Histon Road Corridor

Design Workshops 3 & 4 – Feedback Summary

December 2016

Proposed Design for a 5-way Protected Junction at Histon Rd/Victoria Rd/Huntingdon Rd/Castle St/Mount Pleasant

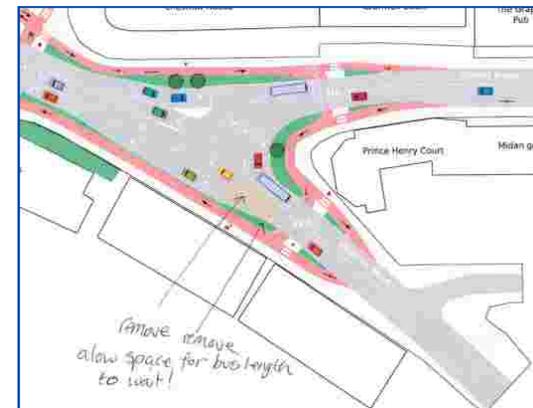
- **All tables reviewed the alternative design presented by Cambridge Cycling Campaign / Histon Road Area Residents Association/ Benson Road Area Residents Association.**
- Although the 'Do maximum' generally scored higher than the 'Existing' (3 out of 4 tables). All tables preferred the alternative design overall in their scoring, with many preferring the fact it retained access to Victoria Road.
- **Groups felt that this design provided better pedestrian and cyclist provision. With a key design factor being segregated cycle lanes for all movements and additional crossings**
- It should be noted that within this design there is very limited bus priority which is a key objective of the scheme.

CURRENT DESIGN

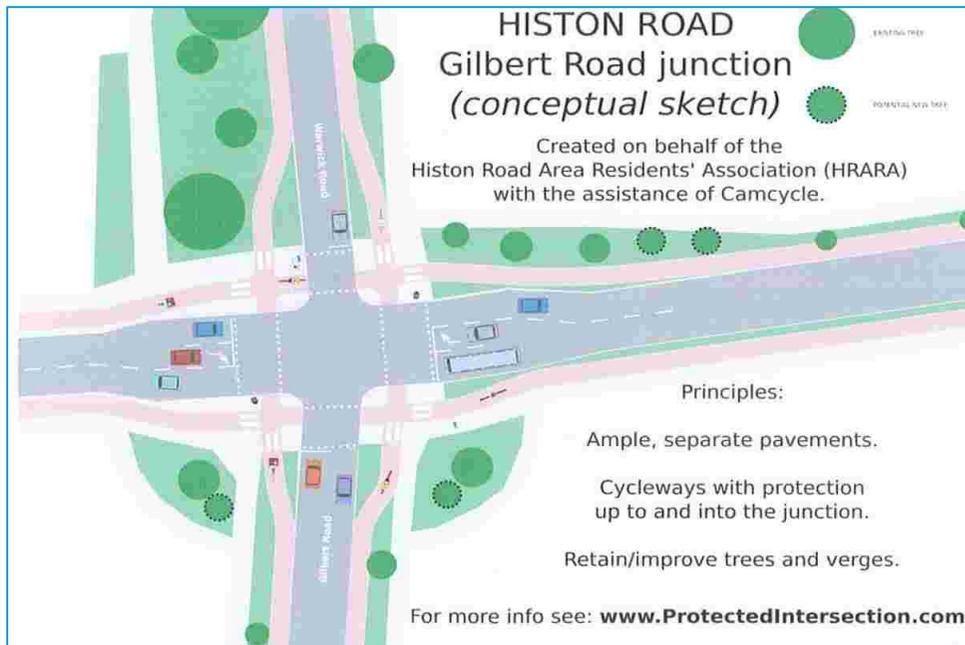
Visibility issue, with trees.

KEY FEEDBACK THEMES – GILBERT ROAD JUNCTION

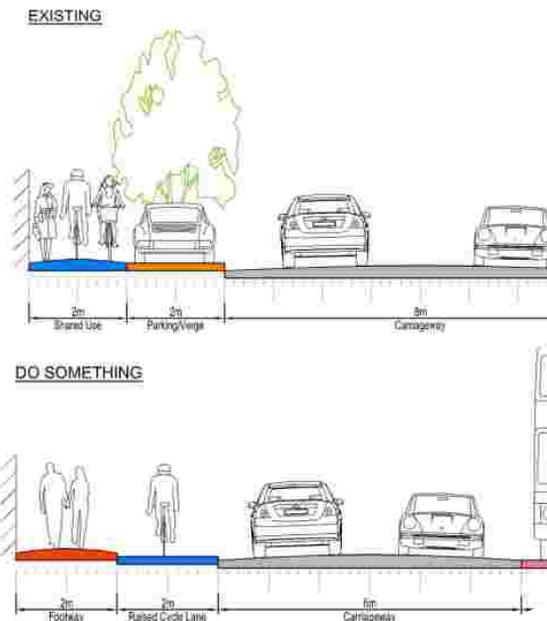
- **Again all tables reviewed the alternative design presented by Cambridge Cycling Campaign / Histon Road Area Residents Association/ Benson Road Area Residents Association.**
- **Two tables preferred the alternative option due to extensive pedestrian and cycling provision. This provision is at the expense of bus priority measures.**
- **However, one table preferred the 'Existing' layout and one preferred the 'Do Maximum' proposal.**

KEY FEEDBACK THEMES – MITIGATION IDEAS & CONCERNS (RAT RUNNING)

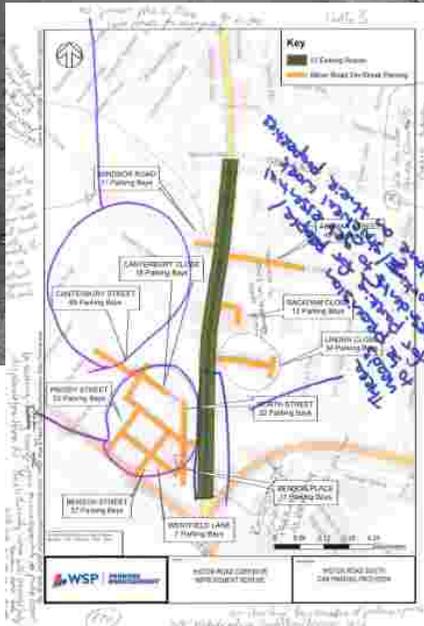
- **Concerns regarding knock on impacts of increased rat running routes and loss of parking for residents.**
- Areas of concern relating to rat running are primarily identified as:
 - Benson Street / Canterbury Street area between Histon and Huntingdon Roads and
 - Oxford Road to Windsor Road link between Histon and Huntingdon Roads.
 - Akeman Street to Stretten Avenue.
- **Desire for Benson Street / Canterbury Street area to become a home zone**
